**The O'Neill Center
Roof Replacement Natatorium**
 WESTSIDE CAMPUS
 WESTERN CONNECTICUT STATE UNIVERSITY

**SKYLIGHT
DETAILS**

Agency
Project No. **BI-RD-311**
By: MAB
Scale: As Noted
Issue Date: 9/18/2019

SUPPLEMENTAL BID NO. 1

3 PVC DETAIL - ADDENDUM
SCALE: 3" = 1'-0"

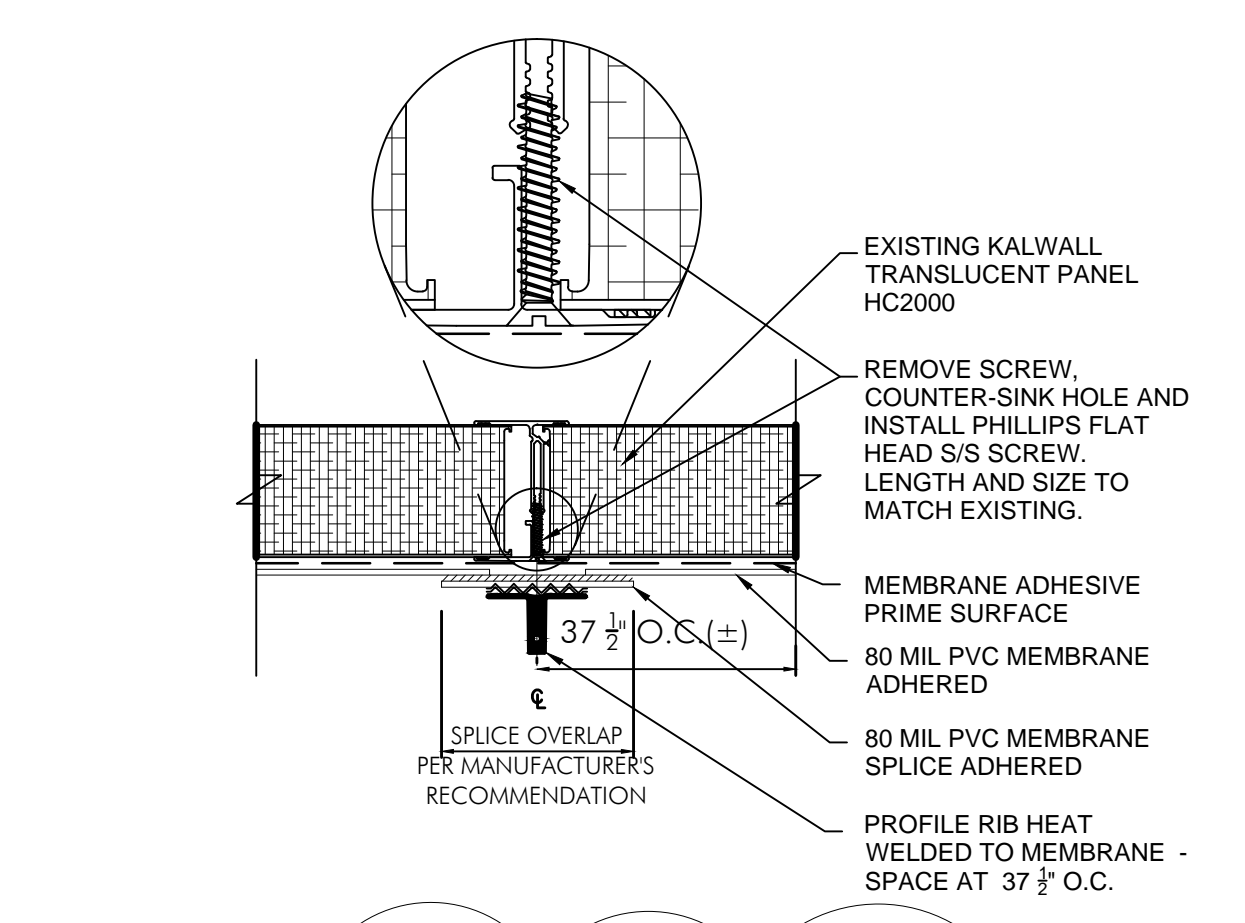
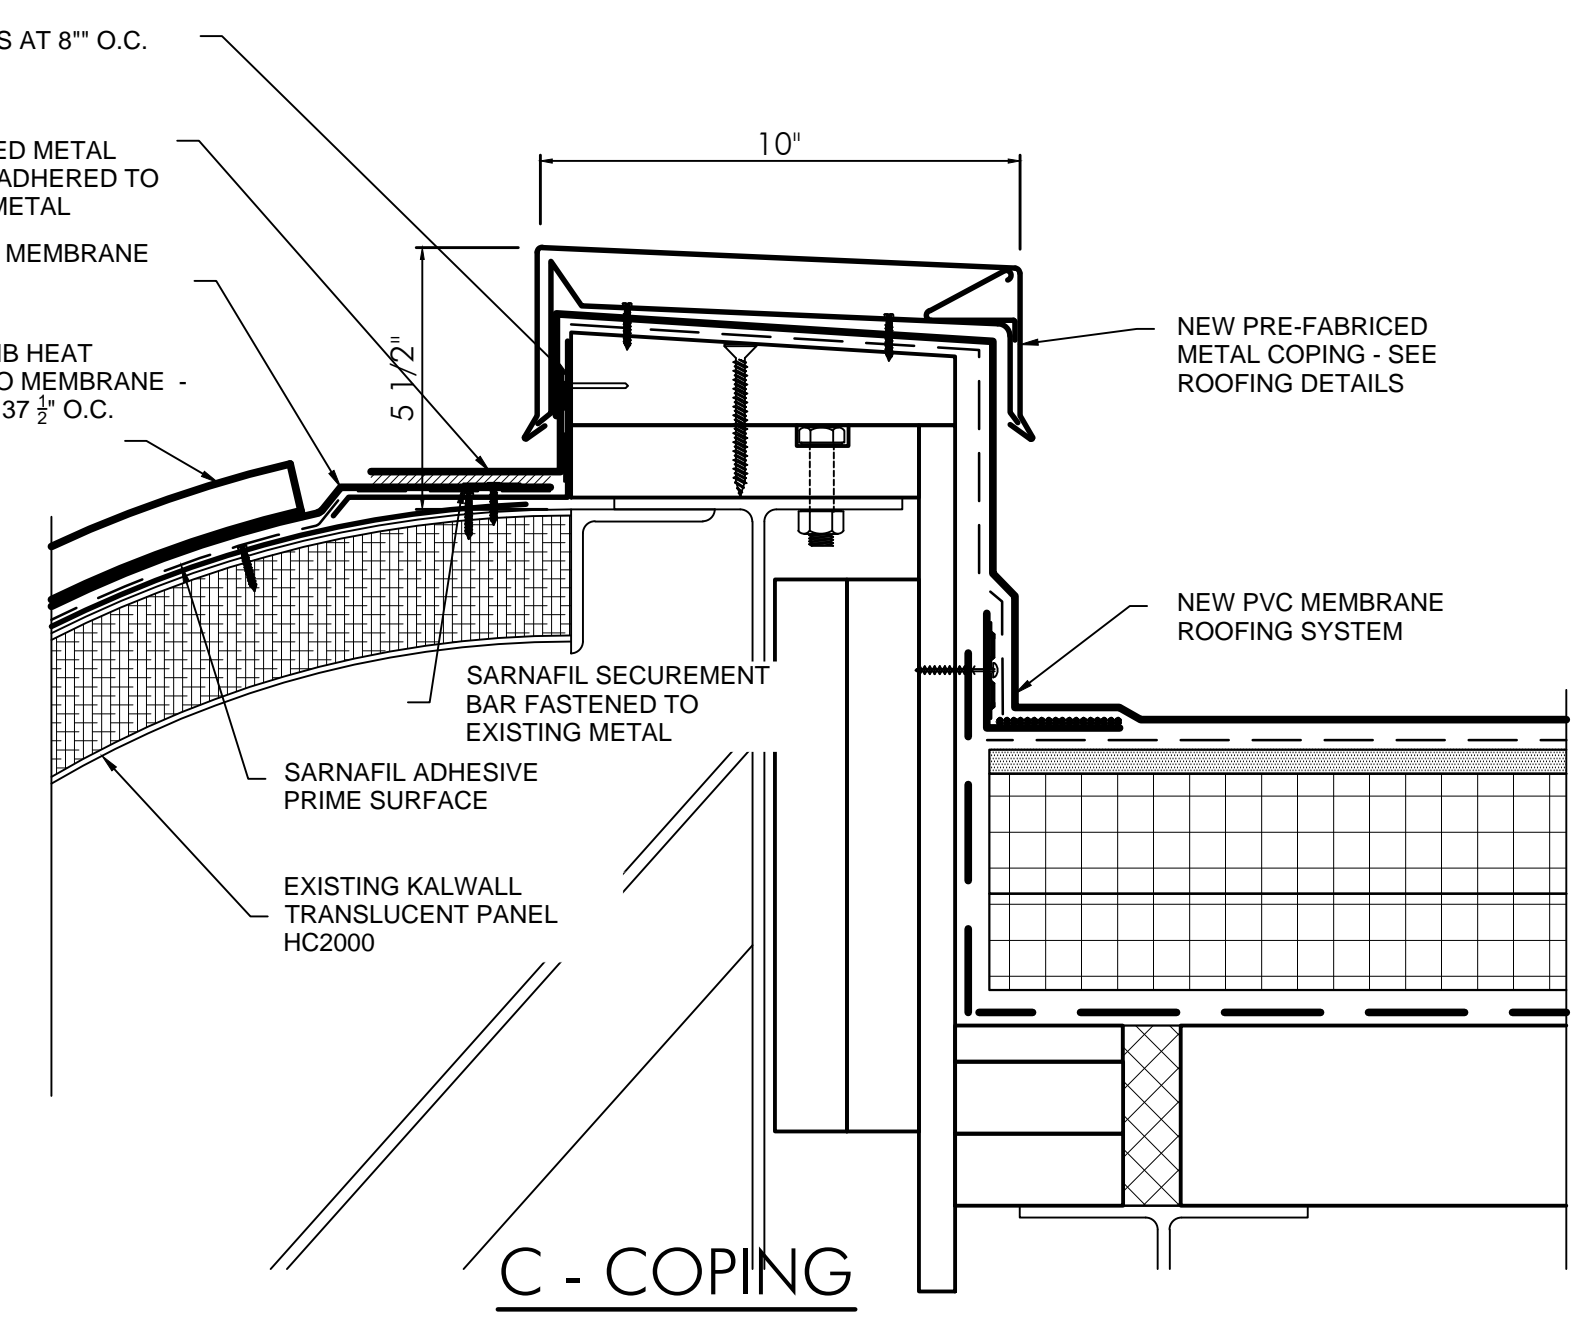
Revisions	
No.	Date
1	11/1/2019 PVC
2	1/3/2020 ADDEN #7
